Panel Reference	PPSSWC-378
DA Number	DA/2023/1020/1
LGA	Wollondilly
Proposed Development	Torrens title subdivision to create 362 residential lots, 6 superlots, 2 drainage reserve lots, 1 open space lot, 3 landscaped area lots, earthworks including allotment grading and associated inter-allotment retaining walls, street tree planting, embellishment of a local park, associated civil and stormwater works, delivery of essential services and dedication of roads.
Street Address	15 Janderra Lane, Wilton
Applicant/Owner	Country Garden Wilton East Pty Ltd/ Risland
Date of DA Lodgement	6 November 2023
Total number of submissions	Nil
Number of Unique Objections	
Recommendation	Approval
List of all relevant s4.15(1)(a) matters	<ul style="list-style-type: none">• relevant environmental planning instruments:<ul style="list-style-type: none">○ State Environmental Planning Policy (Planning Systems) 2021,○ State Environmental Planning Policy (Biodiversity and Conservation) 2021,○ State Environmental Planning Policy (Resilience and Hazards) 2021,○ State Environmental Planning Policy (Transport and Infrastructure) 2021,○ State Environmental Planning Policy (Precincts—Western Parkland City) 2021 (WPC

Figure 2 Drinking Water Catchment

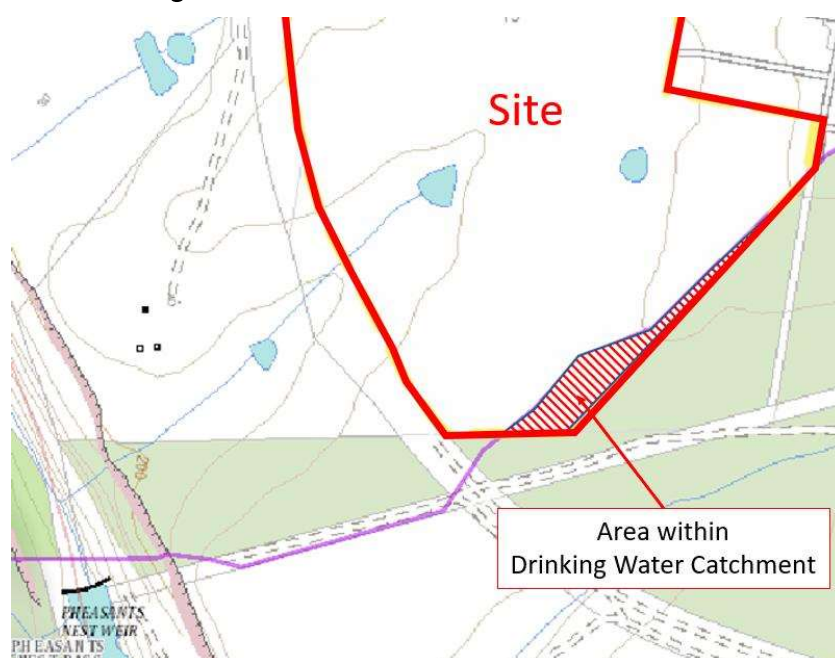
The area of the site within the Drinking Water Catchment is shown in Figure 2. The boundaries of the catchment have been drawn based on 1:25,000 topological contour information.

Review of the civil design plans demonstrate that the perimeter road that passes through the mapped area of the Drinking Water Catchment will deliver run off to the proposed detention basin located adjacent the western boundary. Discharge from this basin will feed into an existing stream that enters the Nepean River tributary below the Pheasants Nest Weir, and outside of the Drinking Water Catchment.

Council is satisfied that the development will not impact on water quality within the Drinking Water Catchment.
